NAIMA's Comments on 2019 Compliance Manual

Subject: Comments from the North American Insulation Manufacturers Association on Docket Number 17-BSTD-02: 2019 ENERGY CODE COMPLIANCE MANUALS

14. Page 4-56 – 4.4.3.5 Buried and Deeply Buried Ducts

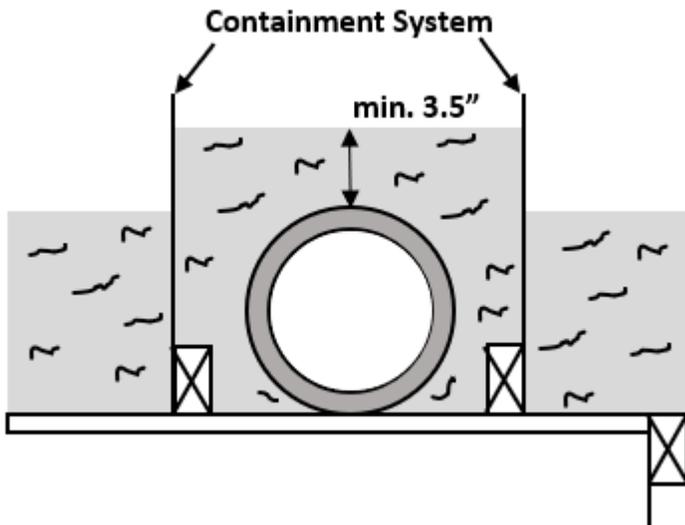
To take credit for buried ducts, the system must ~~meet the verified duct design criteria described above~~, be diagnostically tested for duct sealing compliance by a HERS rater according to Reference Residential Appendix RA3.1, and meet the requirements for quality high insulation installation quality described in Reference Residential Appendix RA3.5.

In addition to the above requirements, the attic area containing the buried ducts must have insulation with uniform depth (not mounded over the duct), level ceiling, and at least 6 inches of space between the duct outer jacket and the roof sheathing.

Alternatively, a containment system may be used, as long as the ducts are enclosed and completely covered by at least 3.5 inches of attic insulation.

Reason – Deeply buried ducts may be achieved by the use of a containment system (e.g. sheetrock, plywood) with a minimum of 3.5” of insulation over the ducts. The use of a containment system will assure that the insulation remains over the buried ducts and the duct effective R-value will remain constant. The 2018 International Energy Conservation Code (IECC) states that ducts can claim an effective R-value of R-25 for deeply buried sections that are directly on or within 5.5” of the ceiling board, surrounded with R-30 or greater attic insulation and buried with a minimum of 3.5” of insulation (from the top of the duct). Under the 2018 IECC the 3.5” of insulation can be achieved by mounding the insulation over the ducts. Because mounding is not an acceptable option under the 2019 Standards, the uses of a containment system would provide builders with another option to reach the deeply buried duct effective R-value under the 2019 Standards and would be

similar to the options under the 2018 IECC. The containment system (shown below) would put the ducts in a better location/environment than the standard ducting practices.

Verified duct design is currently required when taking credit for the buried duct practice. NAIMA also recommends that the verified duct design layout requirement be removed as long as the system meets the duct leakage, fan watt draw and air flow requirements. The quality insulation installation (QII) requirement for buried ducts ensures that the insulation is properly installed in the attic over the buried ducts, so the verified duct design layout is redundant and therefore unnecessary.
